STUDY A 4-30-69

PLANS PREPARED BY CITY OF DETROIT DEPARTMENT OF PUBLIC WORKS CITY ENGINEERS OFFICE BUREAU OF HIGHWAYS AND EXPRESSWAYS		MICHIGAN DEPARTMENT OF STATE HIGHWAYS BURT ROAD OVER JEFFRIES FREEWAY IN DETROIT GENERAL DRAWING	
APPROVED: _____ STRUCTURAL ENGINEER	JOB No. 990 (14)	APPROVED: _____ DESIGN SUPERVISING ENGINEER	SQUAD BOSS DRAWN BY: _____ TRACED BY: _____ CHECKED BY: _____ SHEET OF: _____
REVISIONS		APPROVED: _____ ASST. ENGINEER OF DESIGN	S22 of 82122 J
NO.	DESCRIPTION	DATE	BY

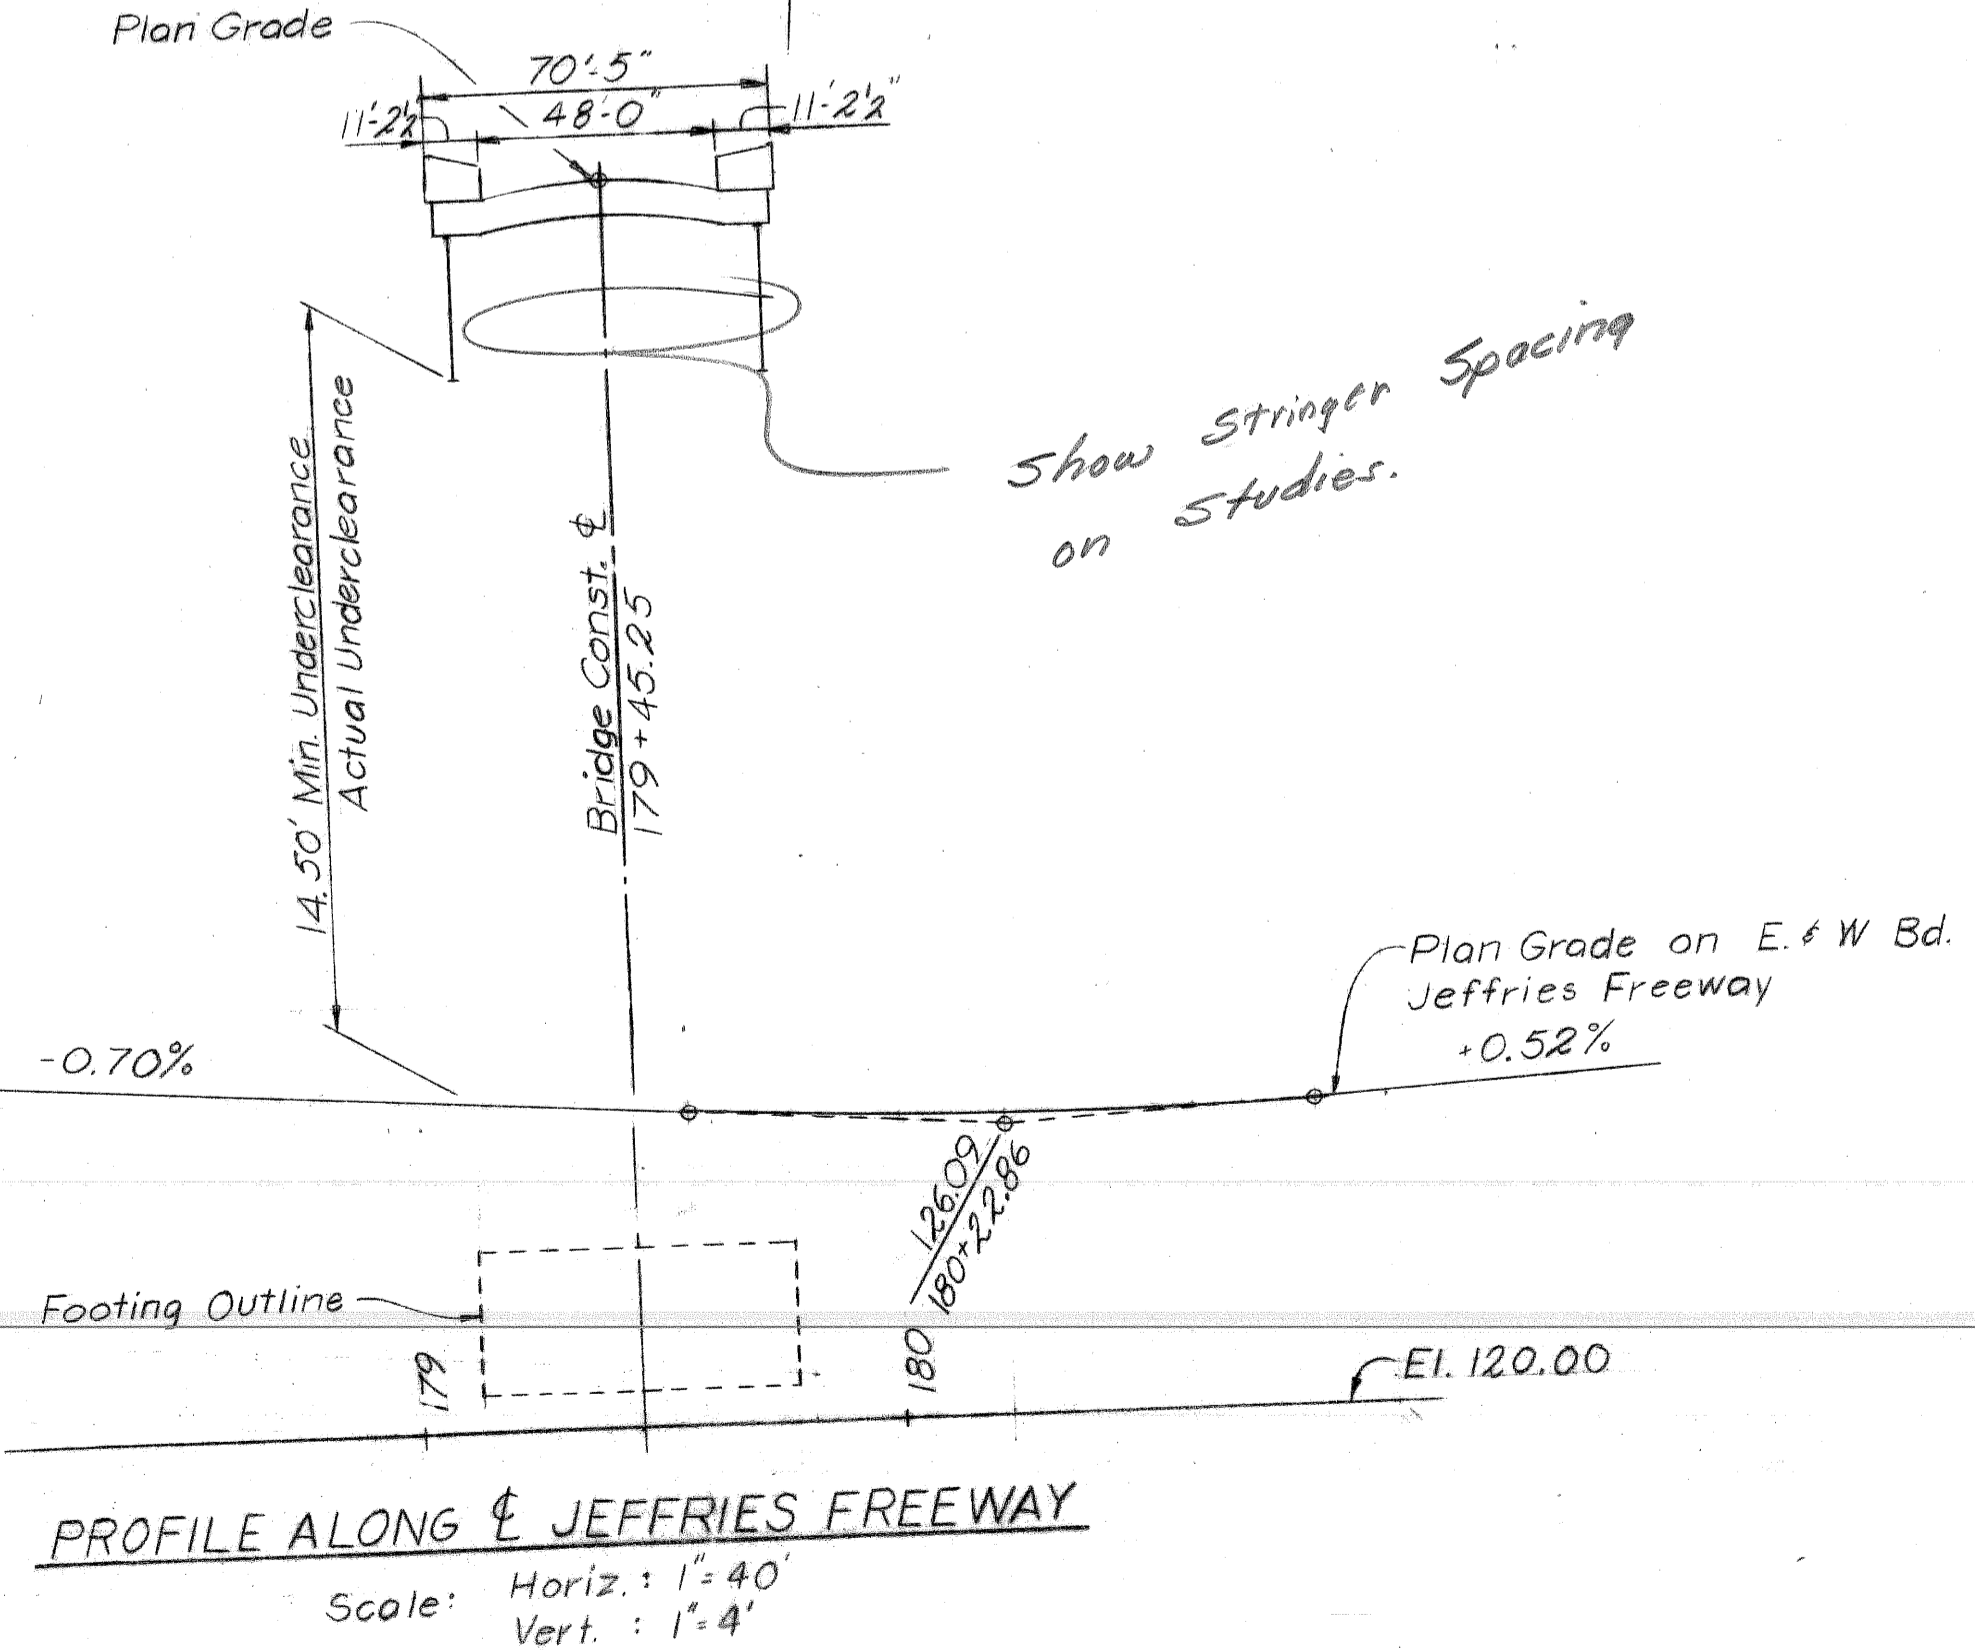
Piles essentially point bearing in stiff clay - same length pile for 40 or 60 - Use 60 Ton

- STUDY NOTES**
- 1) Pile Fndn. required $\left\{ \begin{array}{l} 1 \text{ Pile} \\ 3 \text{ ft. Adv.} \end{array} \right.$ if 60 TON used - please advise 40-ton or 60-ton
 - 2) Lightweight Fill required. $R=1.65$ with fill to limits shown. Limits will be refined in prelim. design, but not less than ~60 ft. behind abutment will be required.
 - 3) $R=1.82$ For $\frac{25}{2}$ near (but not at) bridge.
